**WHITE LAKE TOWNSHIP  
INTER-OFFICE MEMORANDUM  
COMMUNITY DEVELOPMENT DEPARTMENT**

**SUBJECT: Cosmo's Car Wash  
Preliminary site plan approval**  
Property described as parcel number 12-20-276-034, located at the northwest corner of Highland Road (M-59) and Bogie Lake Road, consisting of approximately 1.88 acres, currently zoned (PB) Planned Business.

**RE: Cosmo's Car Wash- Preliminary Site Plan Review – 2<sup>nd</sup> Review**

**RE:** Cosmo's Car Wash  
Preliminary Site Plan – Review #2

BUILDING  
ELEVATIONS  
ENCLOSURE  
ELEVATIONS

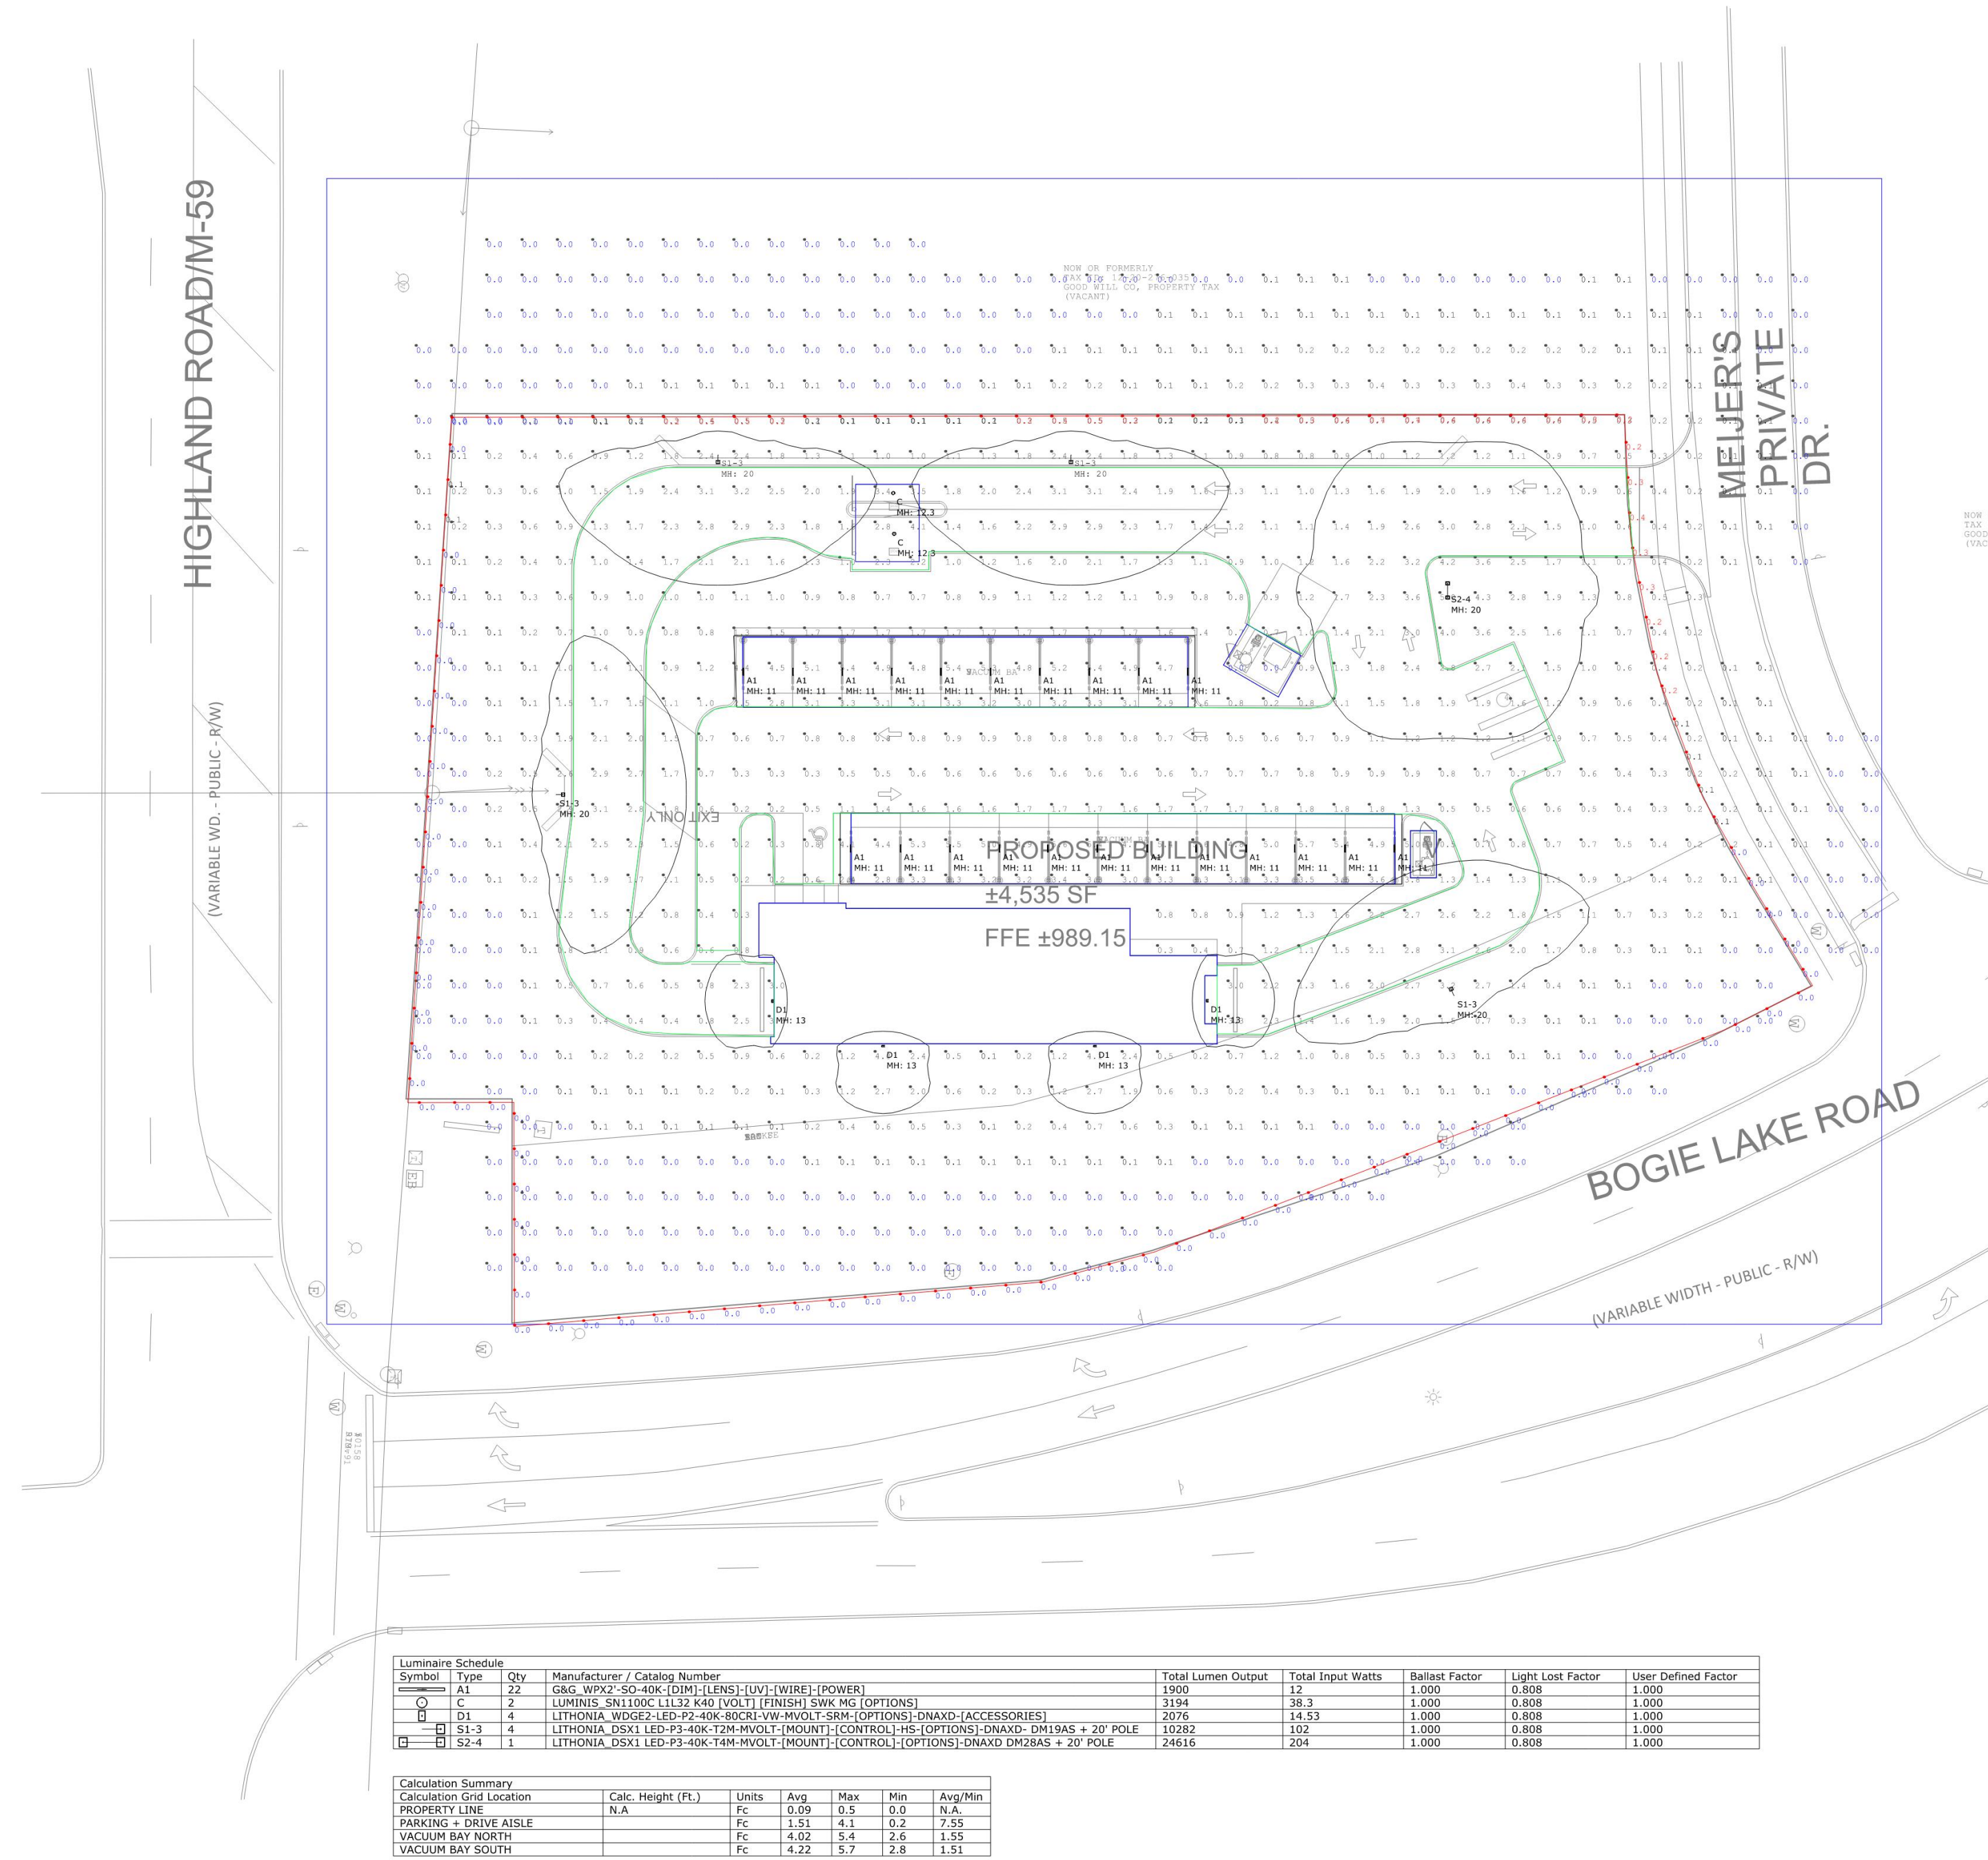
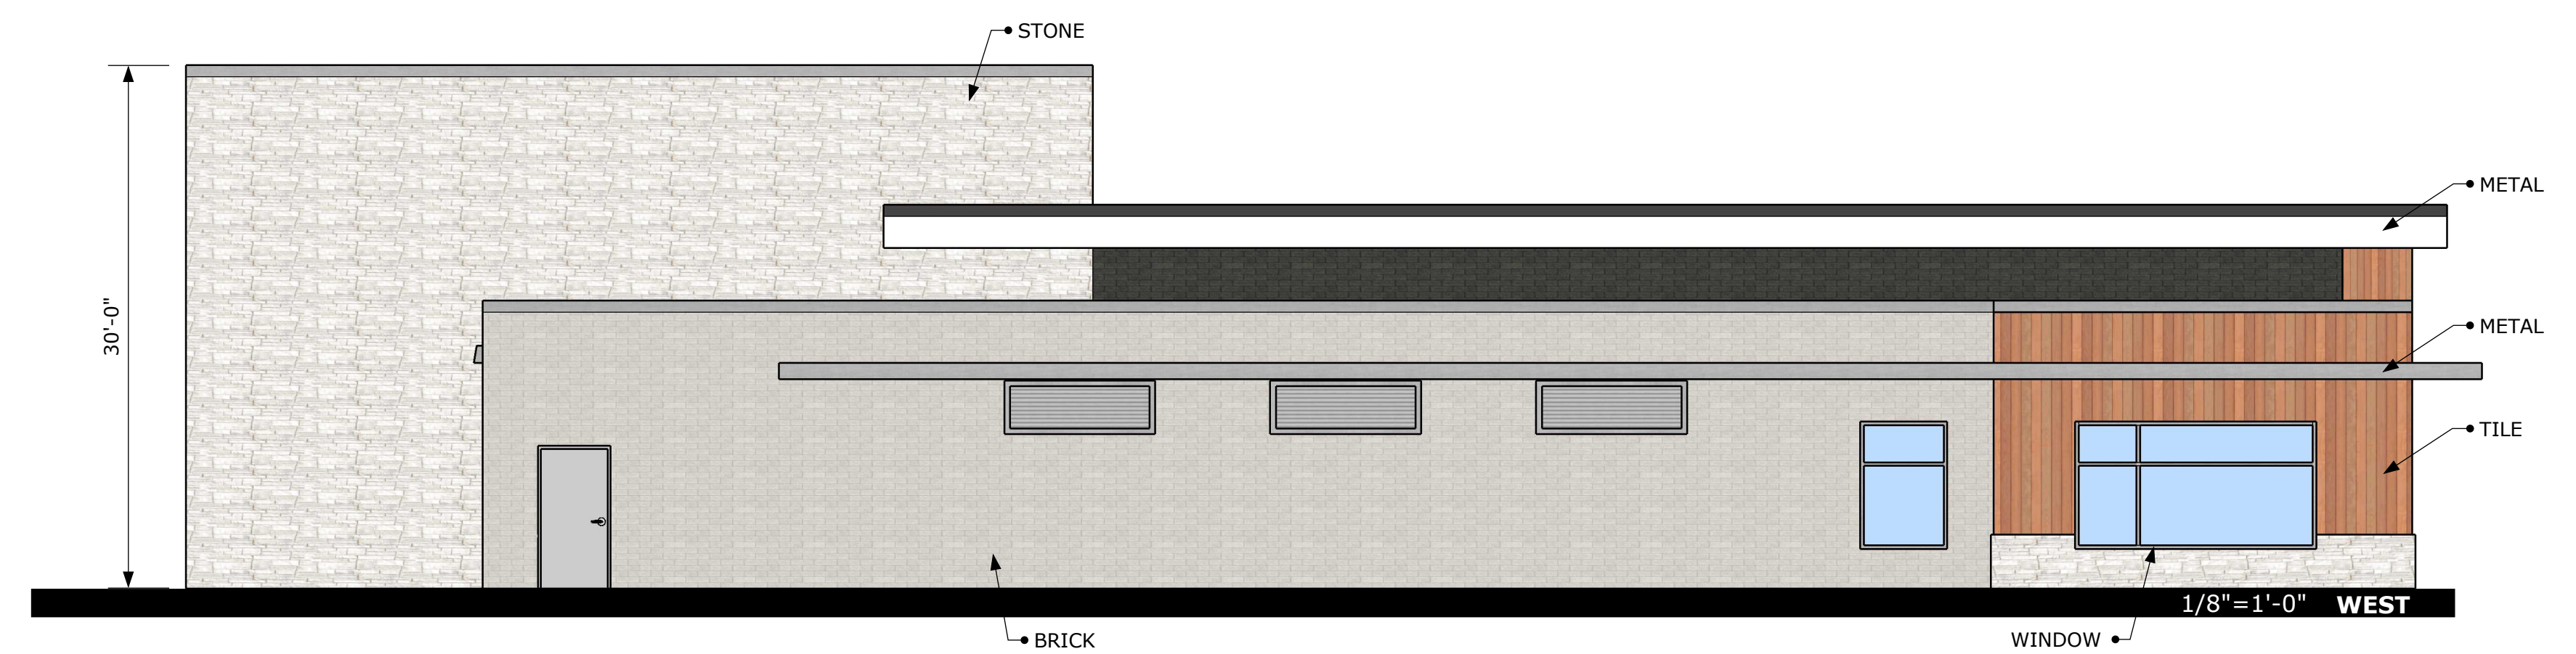
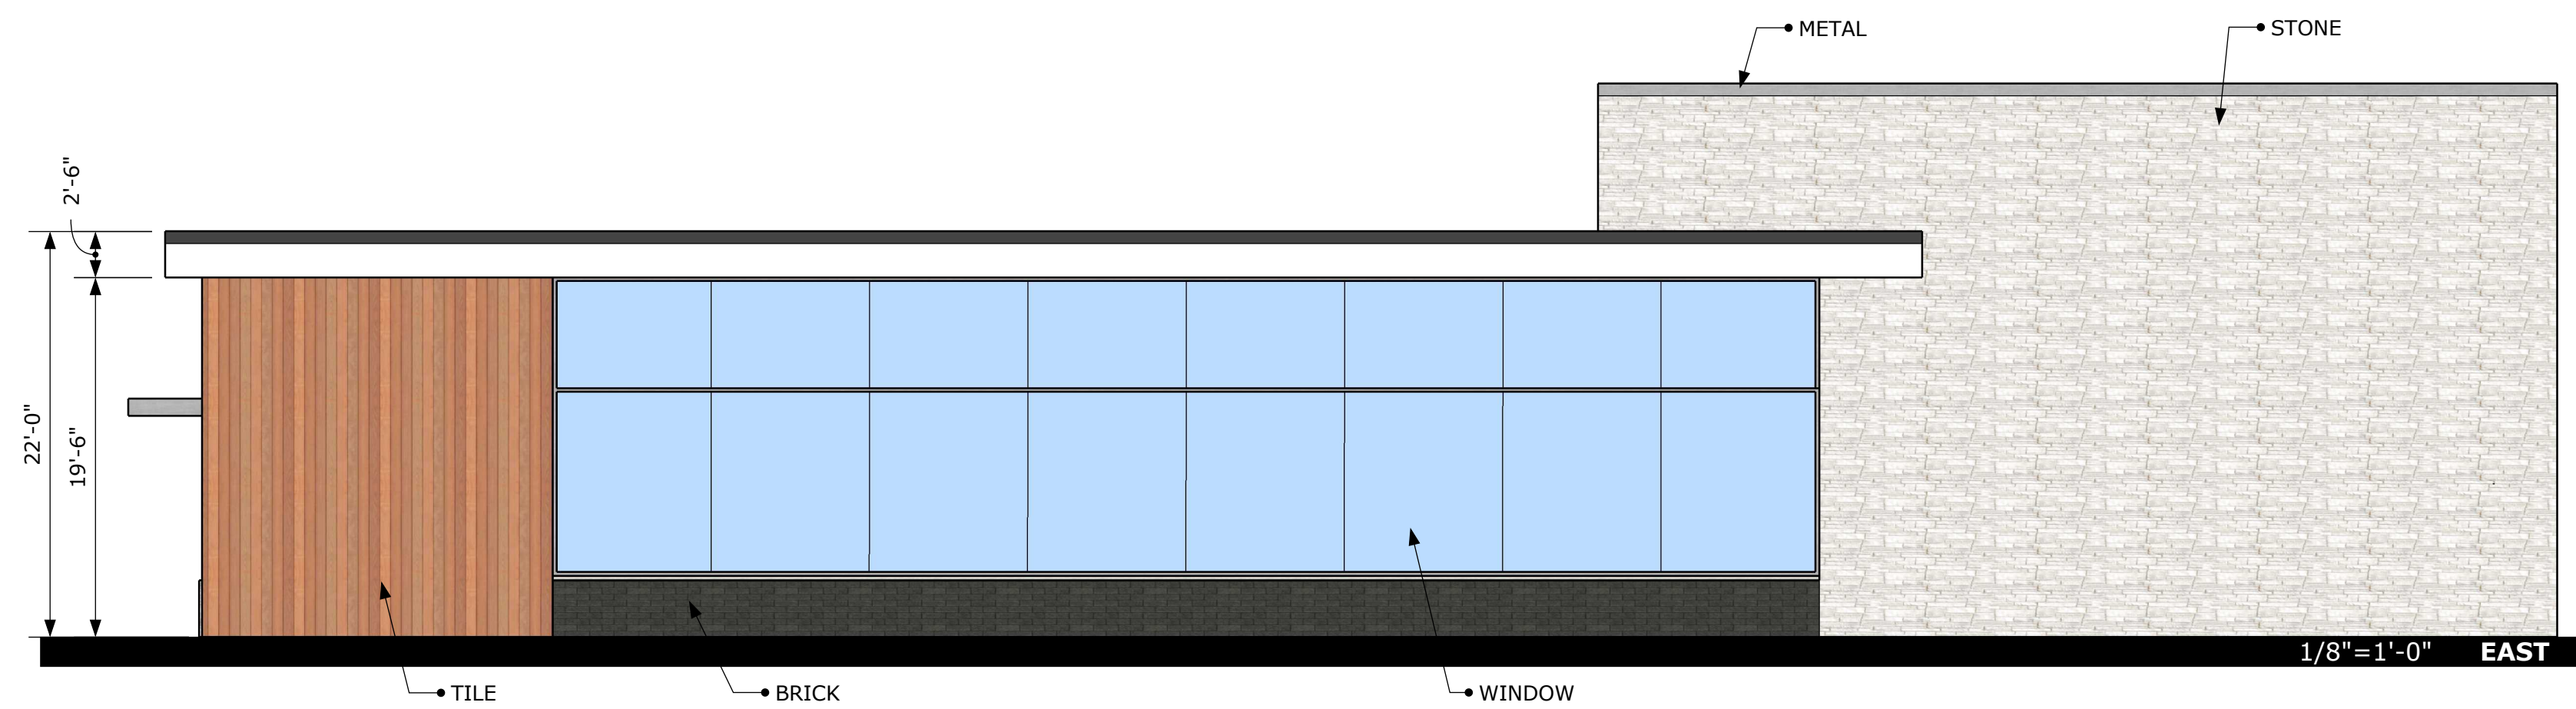
**Seventy (70) percent of all elevations of the building should be covered with some type of brick or cultured stone product. (Comment addressed. Material calculations have been provided on the building elevations showing a majority of the building is finished with glass, brick, and stone. Detailed information on the brick and stone shall be provided at final site plan). The currently proposed color scheme of the building should also be revised; black and grey building material colors are not compatible with or complimentary to the architectural character of surrounding buildings in the Meijer PB district. A brown/tan/taupe color scheme should be utilized on the building. (Comment addressed. An earth tone color scheme is proposed for the building). If any of the Trespa facade system is proposed on the revised building elevations, the color shall be revised to complement the brick and/or stone product utilized. The blue color is considered a sign, which would not be allowed on other buildings in the Township. (Comment addressed. The blue Trespa facade system is no longer proposed).**

**All buildings shall have windows at eye level covering at least 30 percent of the front facade (north, south, and east elevations of the building). The building elevations shall be revised to provide the required windows, and a window coverage calculation shall be provided in the materials table on the building elevations. (Comment addressed. However, the south facade has 29% window coverage. Therefore, a 1% waiver is required).**

**No overhead doors shall face the street, unless approved by the Planning Commission based upon a finding that the door is recessed back from the front facade and properly screened from public view. The overhead doors are not recessed back from the other portions of the facade; the plans shall be revised to achieve such recession. (Comment addressed. The carwash overhead doors are recessed anywhere from approximately two and no more than five feet back from the front (north and south facades). Additionally, the Planning Commission must determine if the overhead doors are properly screened from view; the doors should not be visible from the adjacent roadways. (Comments remain as a notation).**
